STAFF REPORT: 02-12-2020 MEETING

APPLICATION NUMBER: 20-6623

ADDRESS: 4060 STURTEVANT

SCOPE: REMOVAL OF STEEL CASEMENT/TRANSOM/SIDELIGHT WINDOWS; INSTALLATION OF FIBREX CASEMENT WINDOWS

Exterior Condition

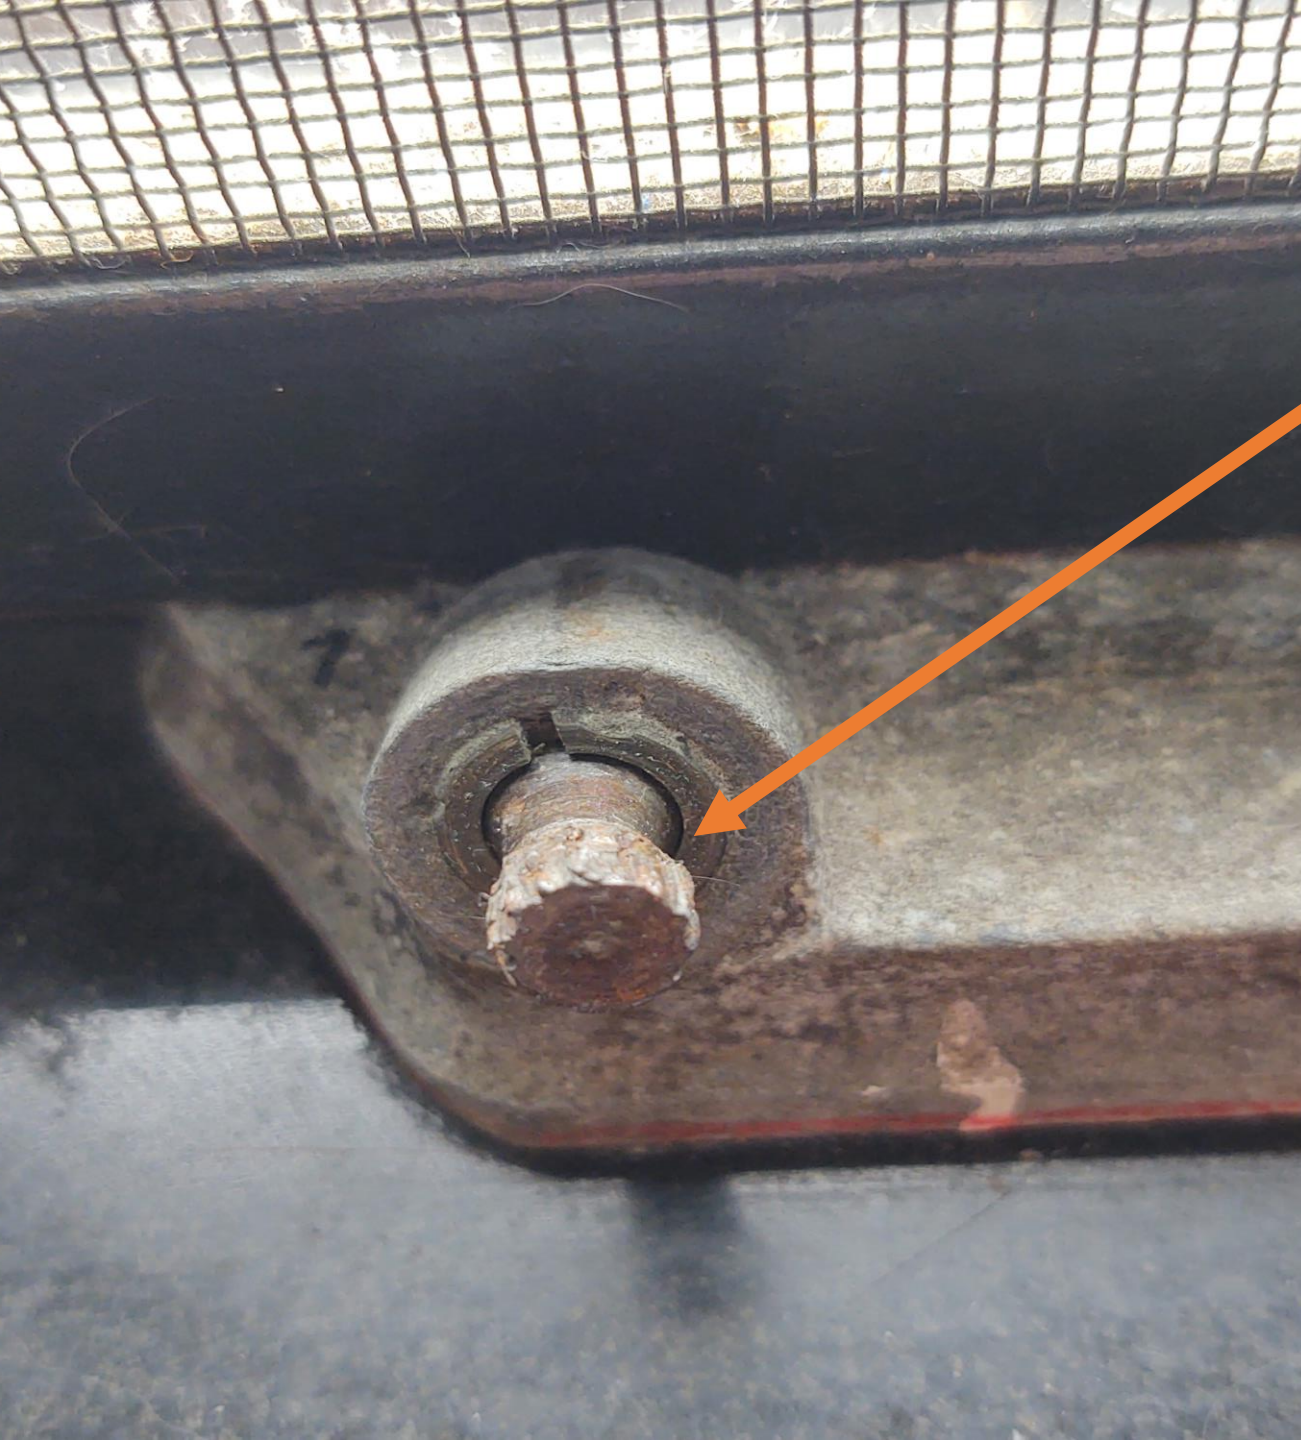
- Top rail (paint is peeling/bubbled)
- Can see through gaps around the operable (casement) sash

Exterior Condition

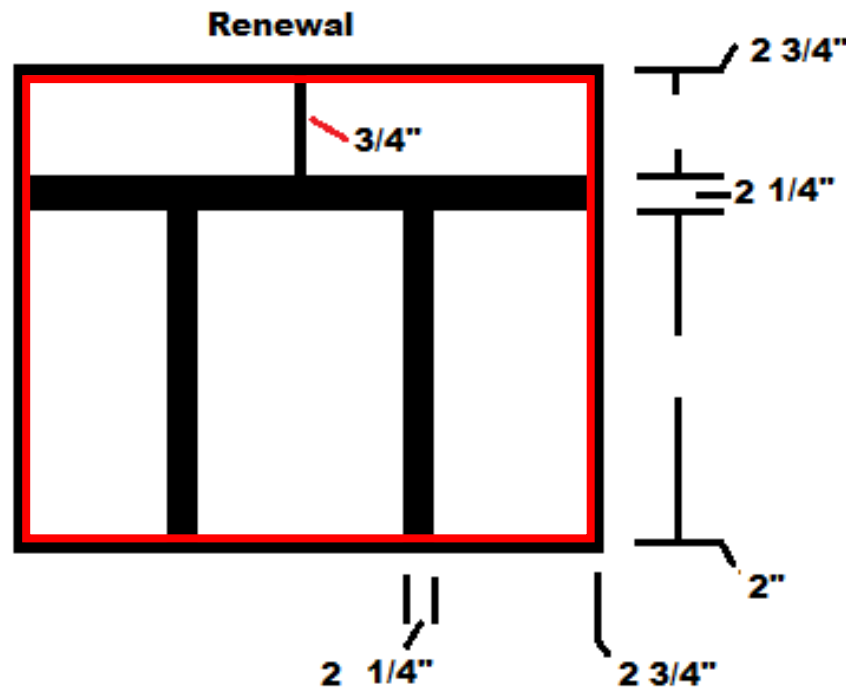
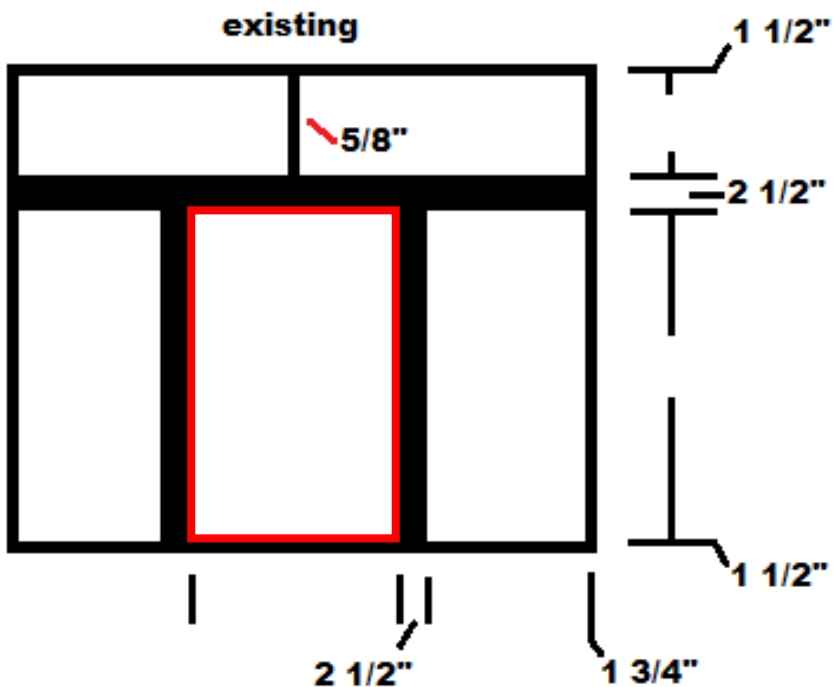
- Most of the windows are missing crank handles
- Some of the knobs are rusted/stripped

- Units 101 and 102
- Center window should open

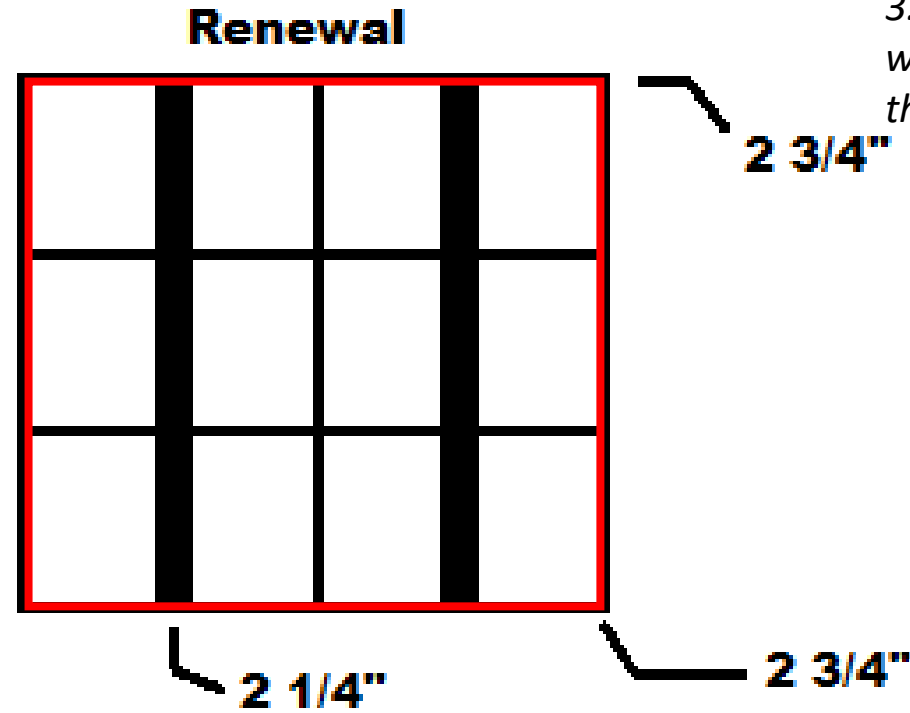
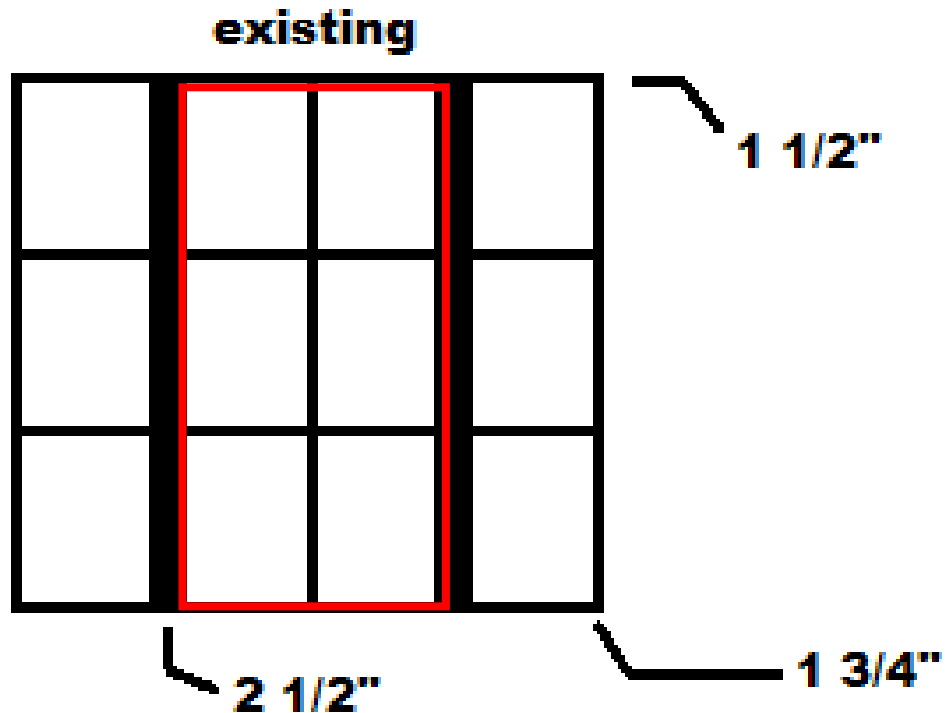
- Renewal:
- 1 large casement single window with a 2 1/4" simulated check rail to mimic the wide bars

• Installing a fixed window at the top and the sides of a casement window is possible, but it would cause a huge 3.5-4" mull between all of the windows joined together, so I don't think this is an option.

- Units 103, 104, 202
- Center window should open

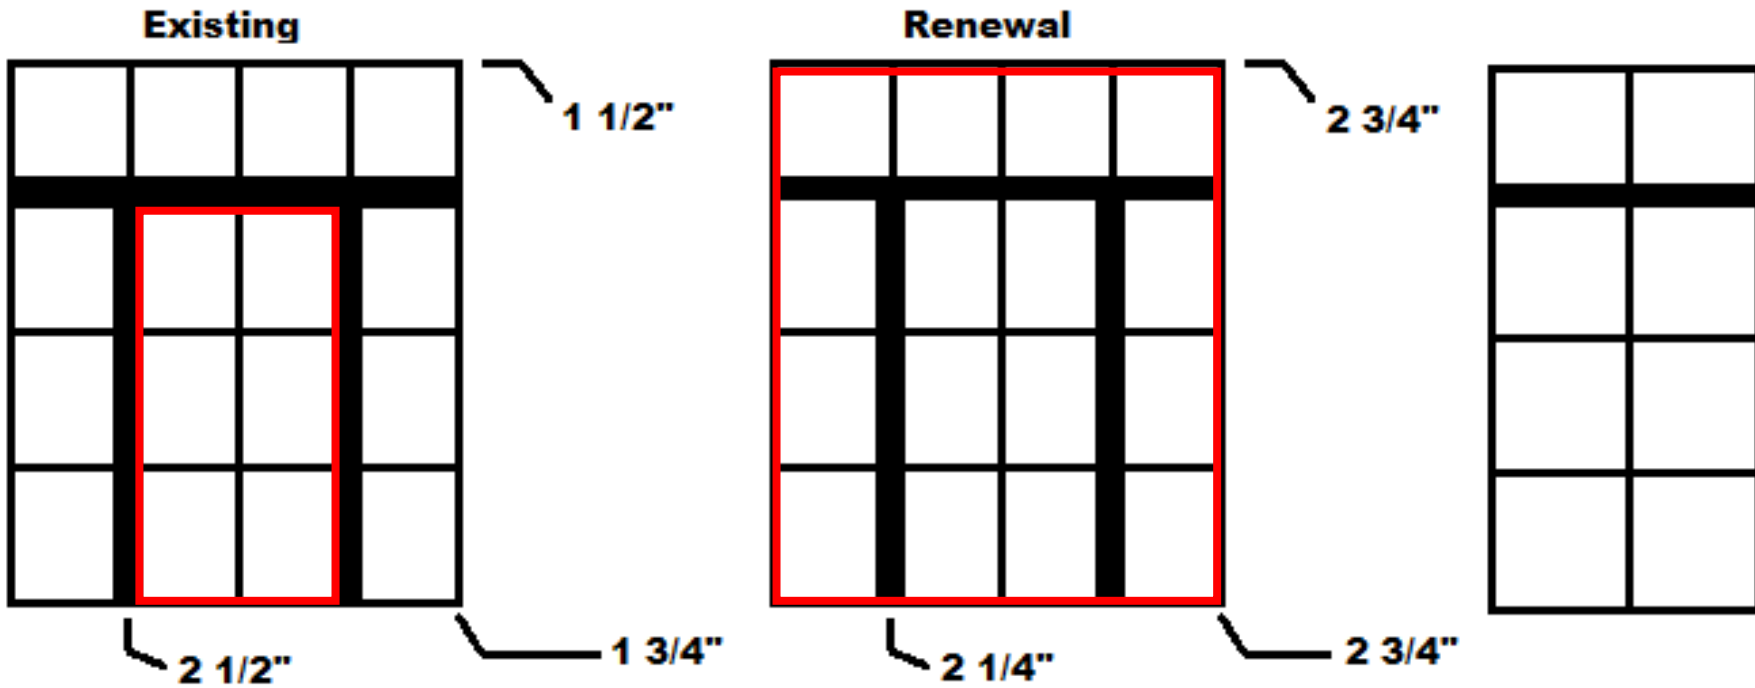
- Renewal:
- 1 large casement single window with a 2 1/4" simulated check rail to mimic the wide bars
